ADDENDUM NO. 1

Sedgwick County Project: Webb Road between 79th and 87th Streets South (R367)

The items contained herein now become a part of the referenced plans and specifications. Please read the following items and acknowledge receipt of this addendum on the Proposal Page Number P-1. NOTE: THIS ADDENDUM MUST BE ACKNOWLEDGED TO CONSTITUTE A VALID BID.

COUNTY	STATE	PROJECT NUMBER	FISCAL YEAR	SHEET NO.	TOTAL SHEETS
SEDGWICK	KANSAS	R367	2023	5R	57

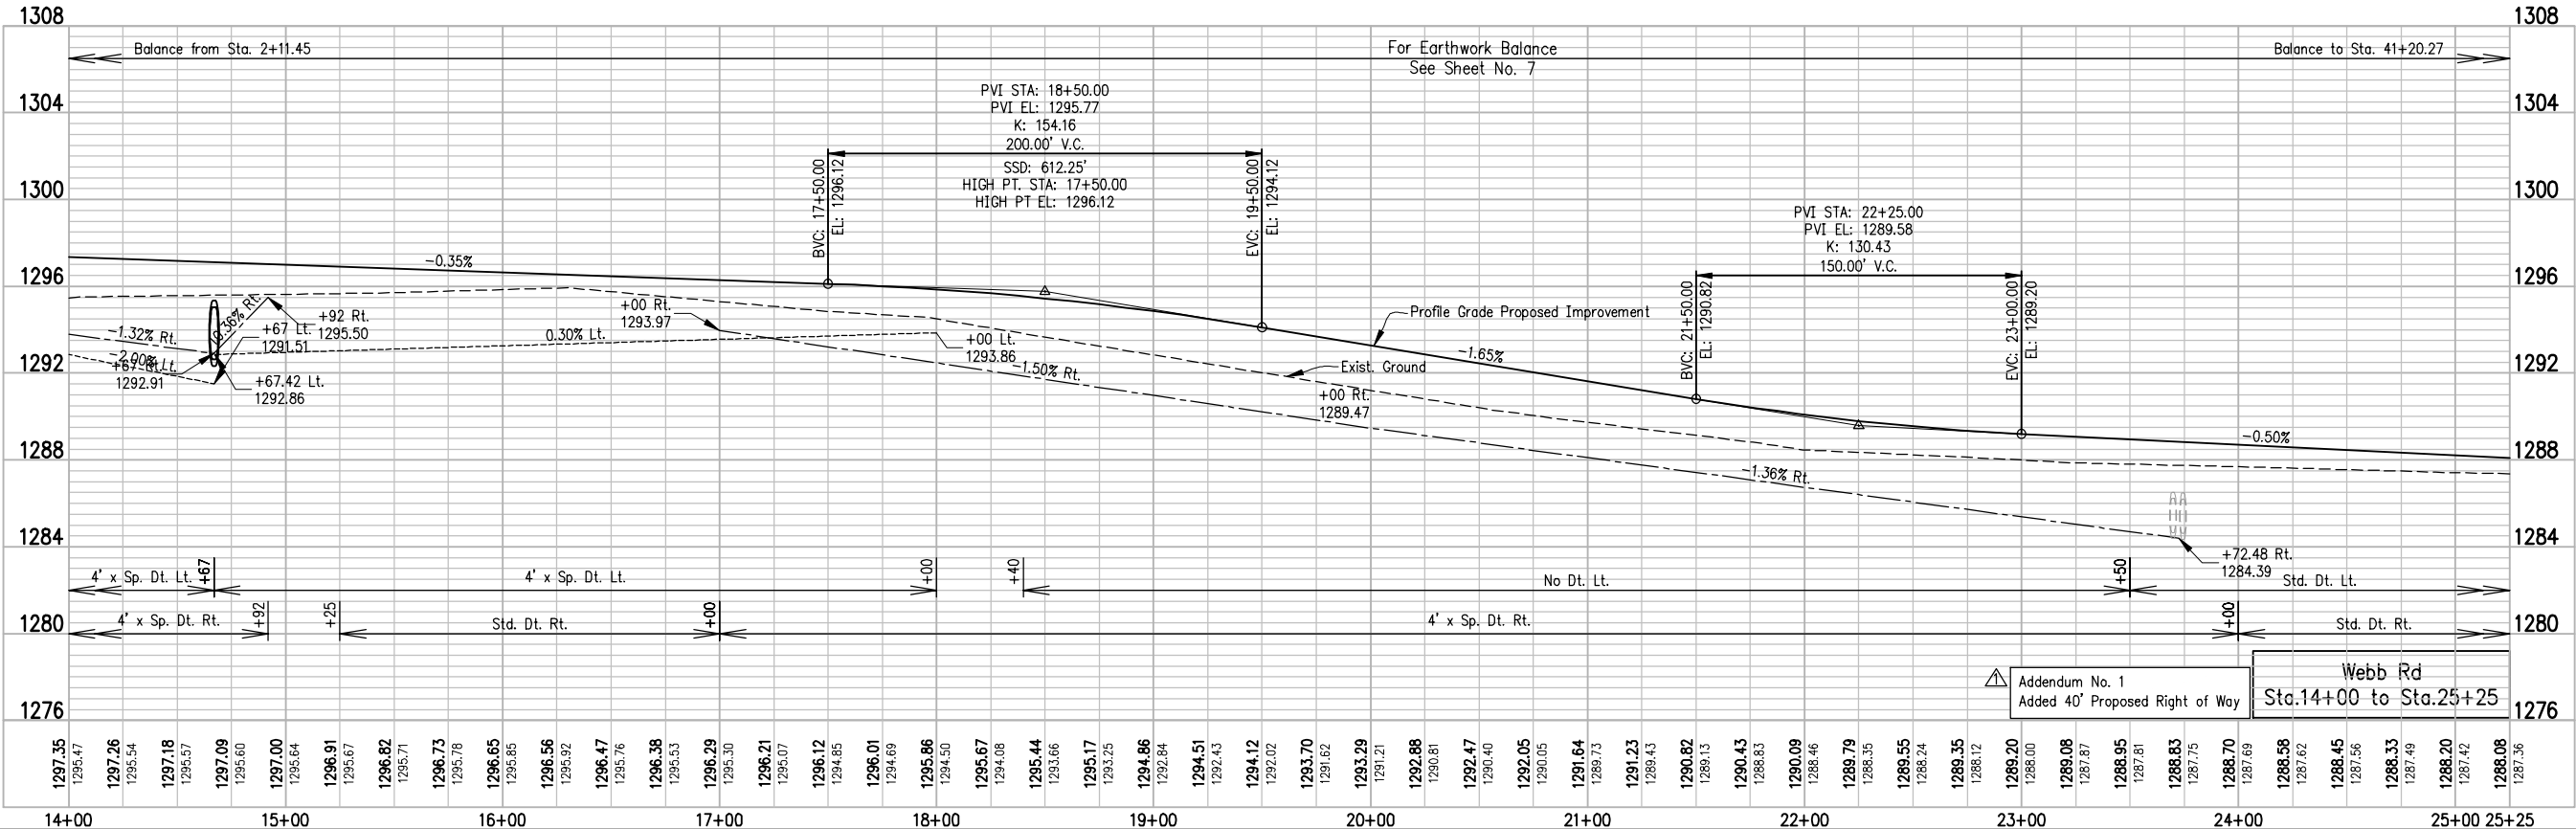
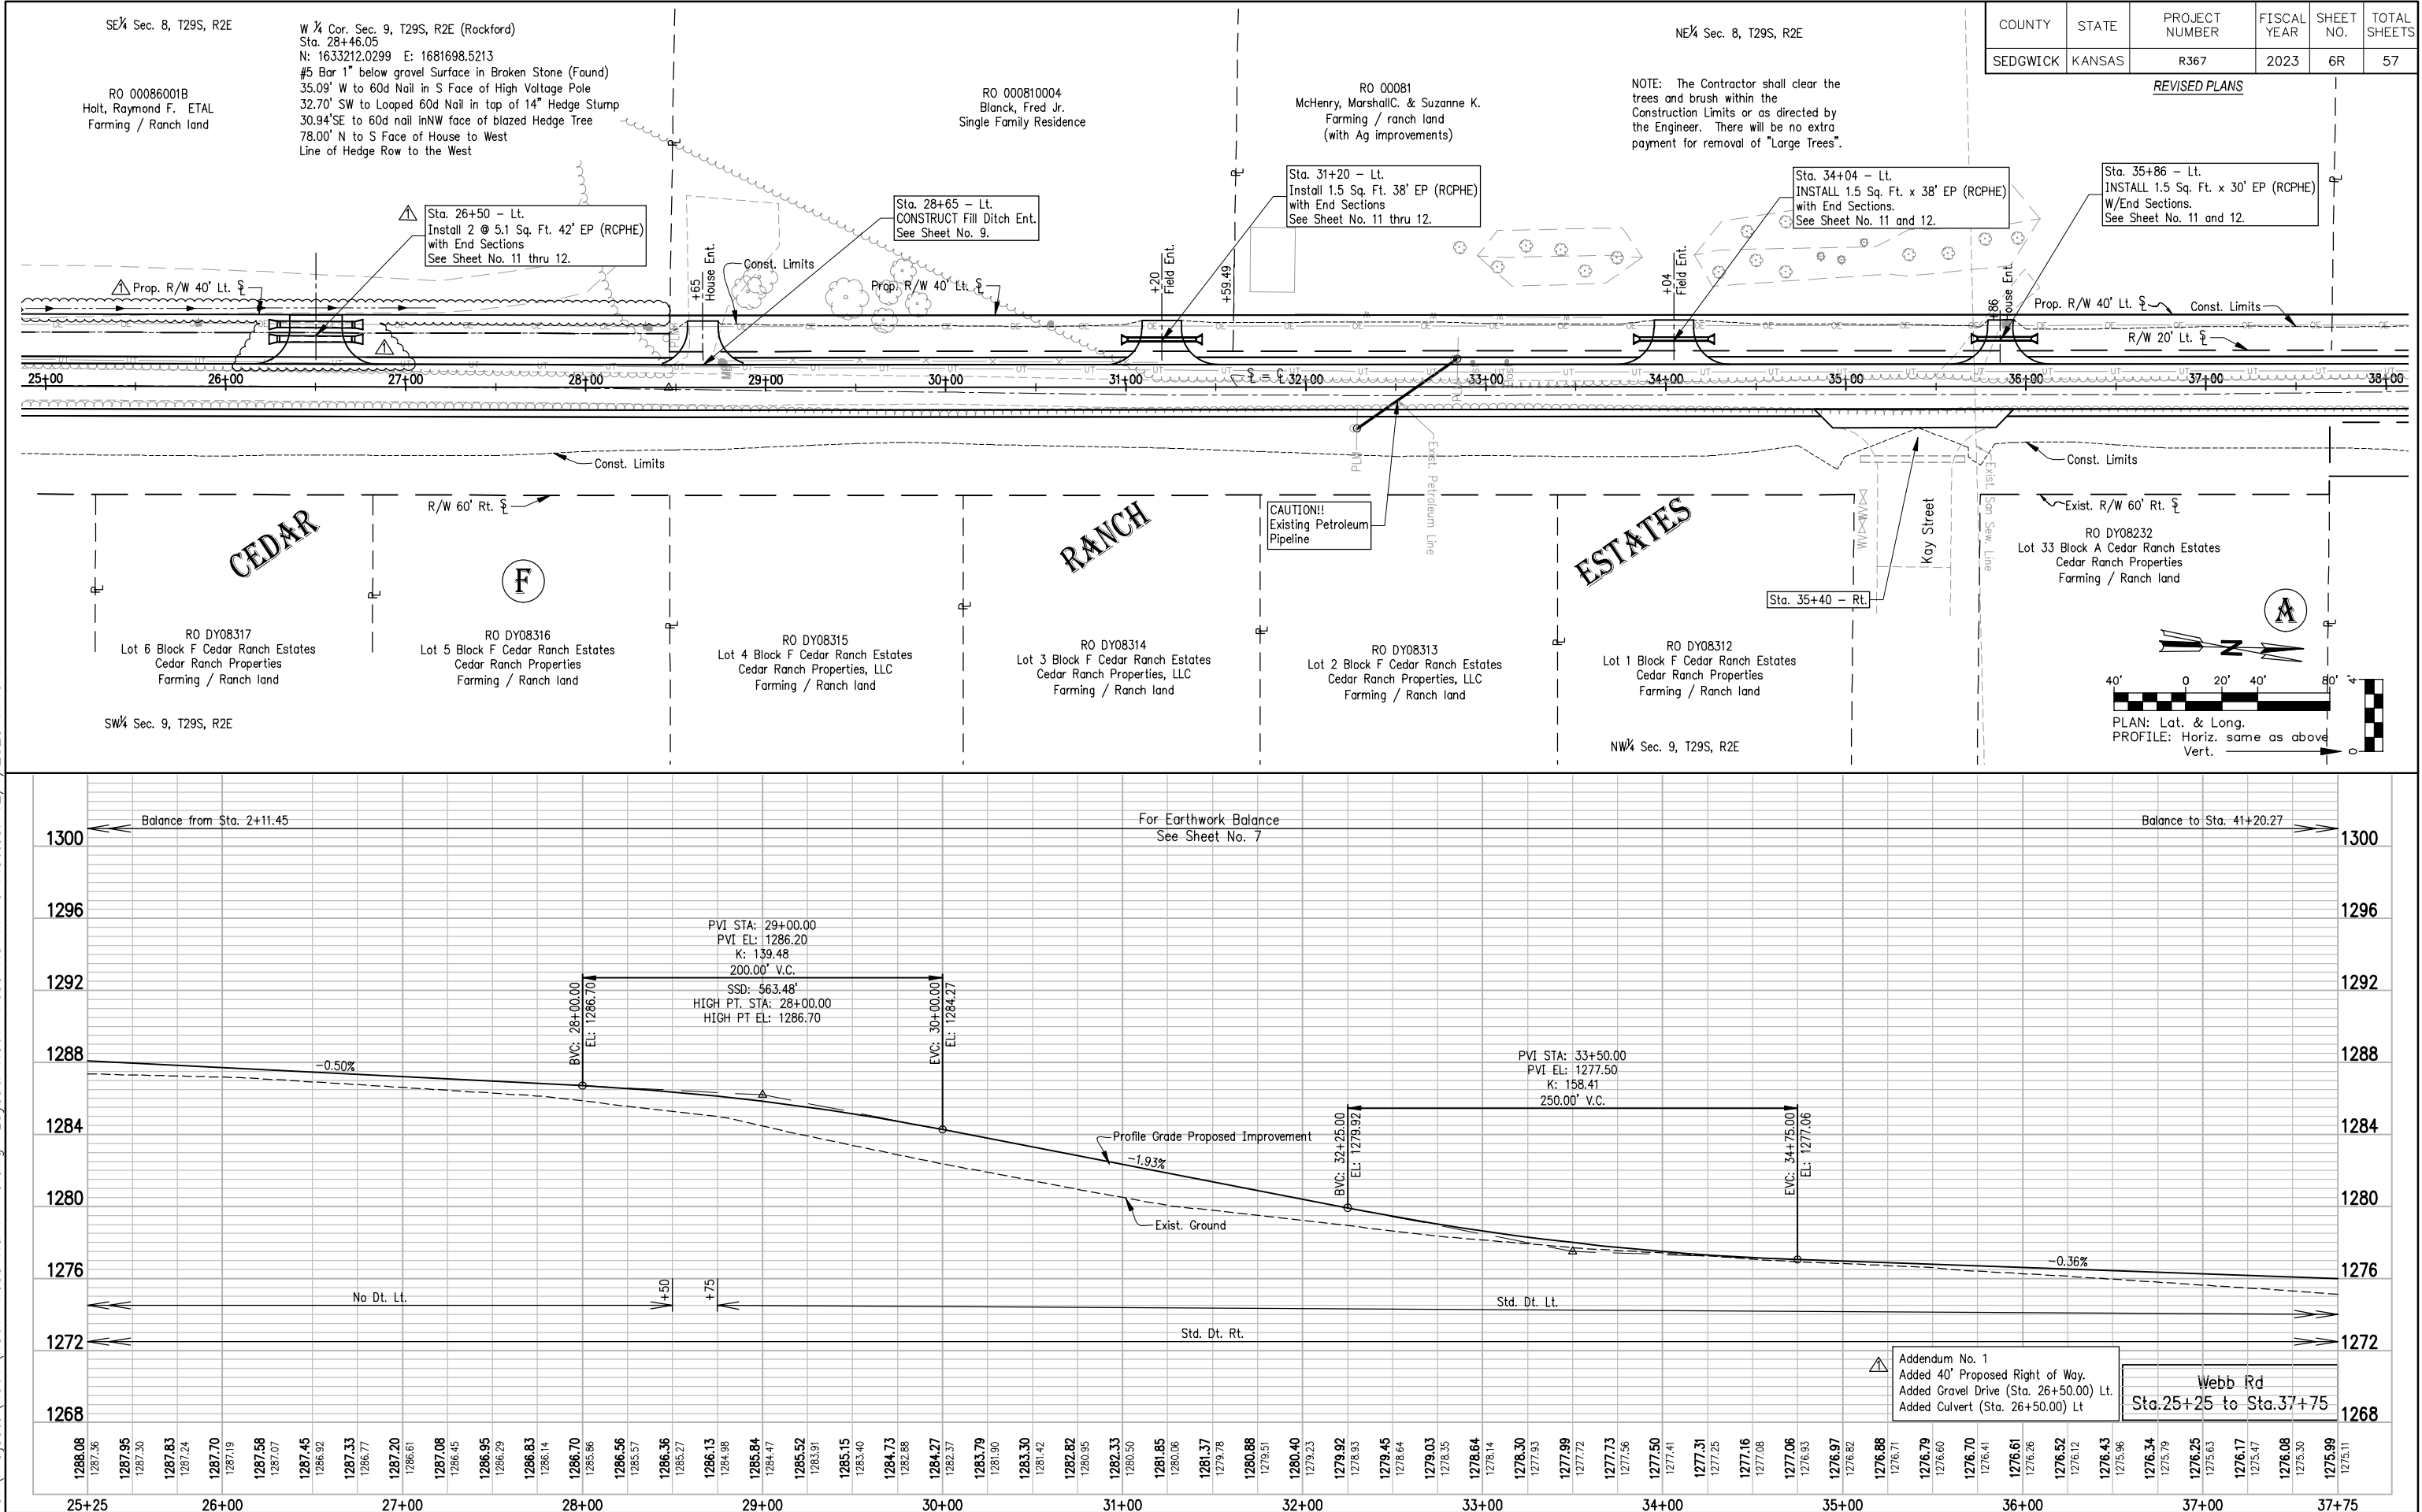
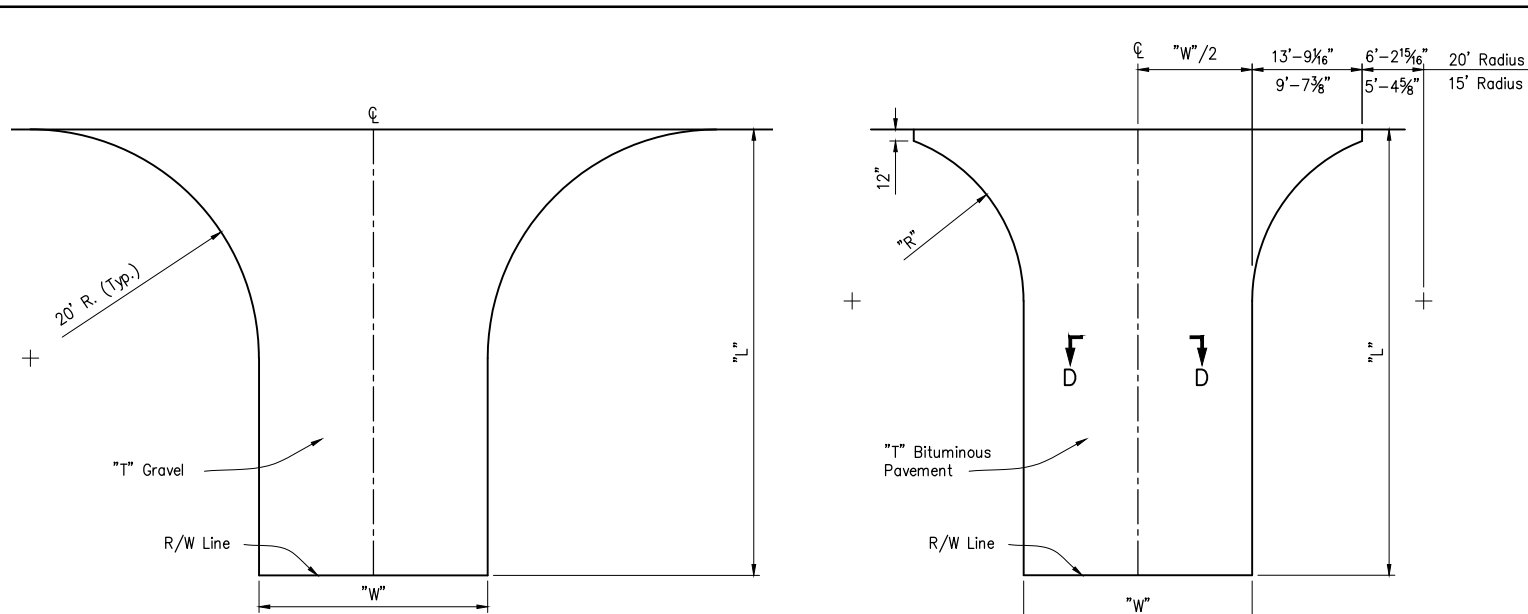
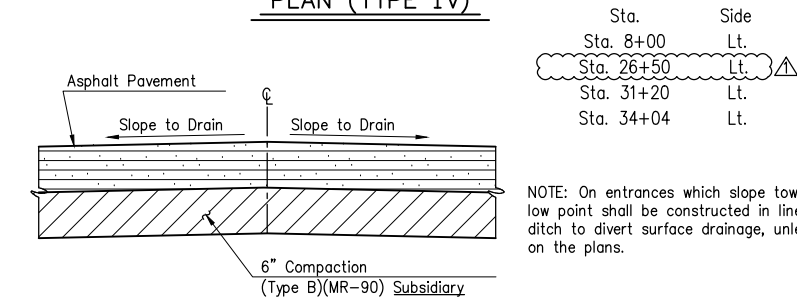
- Replace Sheet 5 with Sheet 5R. Additional Right-of-Way on the Left Side from the Holts.
- Replace Sheet 6 with Sheet 6R. Additional Right-of-Way on the Left Side from the Holts. Additional field entrance at Sta. 26+50 (Lt.)
- Replace Sheet 9 with Sheet 9R. Additional field entrance at Sta. 26+50 (Lt.)
- Replace Sheet 12 with Sheet 12R. Additional culverts at proposed field entrance at Sta. 26+50 (Lt.)
- Replace Sheet 13 with Sheet 13R. Additional culverts at proposed field entrance at Sta. 26+50 (Lt.)
- Replace Sheet 14 with Sheet 14R. Additional “Surfacing Material (AB-3)” at proposed field entrance at Sta. 26+50 (Lt.)

The County has acquired an additional ten feet (10') of right-of-way from Sta. 21+41 to Sta. 28+46 (Lt). The total right of way in this area on the left side is now 40'. The owner is harvesting some of the hedge trees in this area. Any trees remaining at the start of construction operations are to be cleared and grubbed by the Contractor.

Addendum No. 1
Added 40' Proposed Right of Way

COUNTY	STATE	PROJECT NUMBER	FISCAL YEAR	SHEET NO.	TOTAL SHEETS
SEDGWICK	KANSAS	R367	2022	9R	57

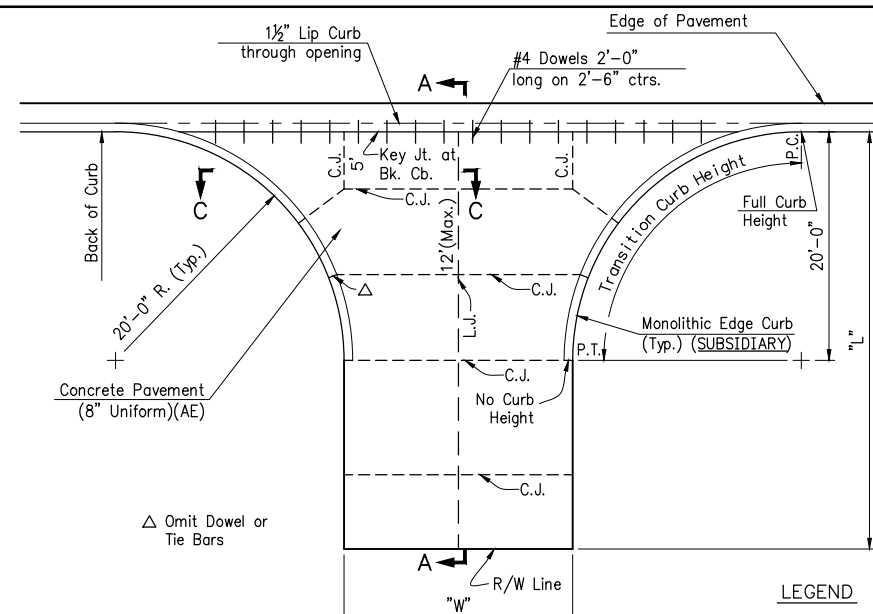
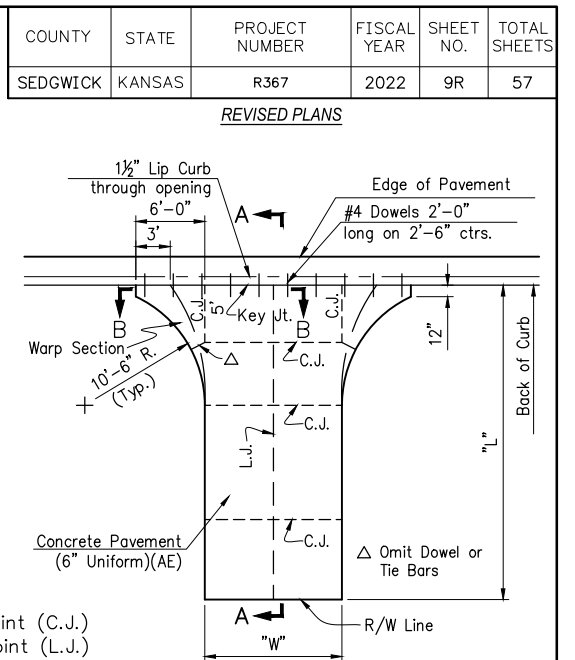
Add entrance at Sta. 26+50

RD051		14/57	
FHWA APPROVAL	9-06-06	APP'D.	James O. Brewer
DESIGNED	DETAILED	QUANTITIES	TRACED Bowser
DESIGN CK.	DETAIL CK.	QUAN.CK.	TRACE CK. Hecht

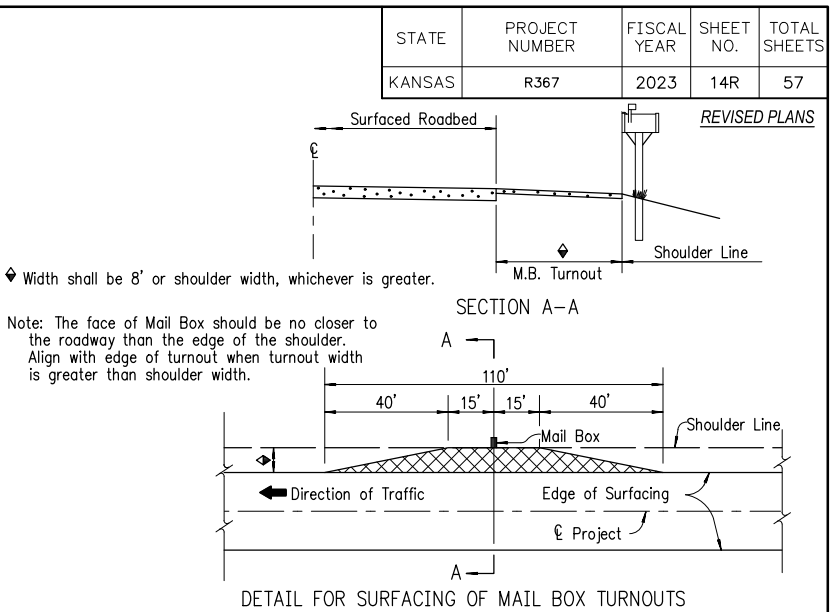
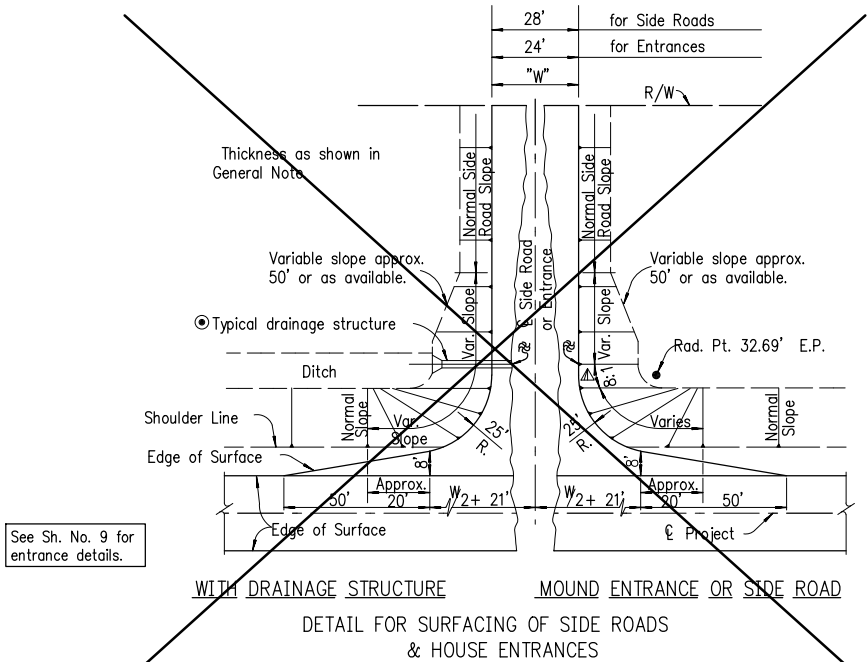
Addendum No. 1 Added Gravel Drive (Sta. 26+50.00) Lt.			
12	1-10-07	Changed bituminous to asphalt	S.W.K. J.O.B.
11	8-30-06	Changed tack type/rate	S.W.K. J.O.B.
10	3-24-05	Revised compaction, tack type/rate	S.W.K. J.O.B.
9	6-12-02	Added low point off shoulder.	S.W.K. J.O.B.
NO.	DATE	REVISIONS	BY APP'D
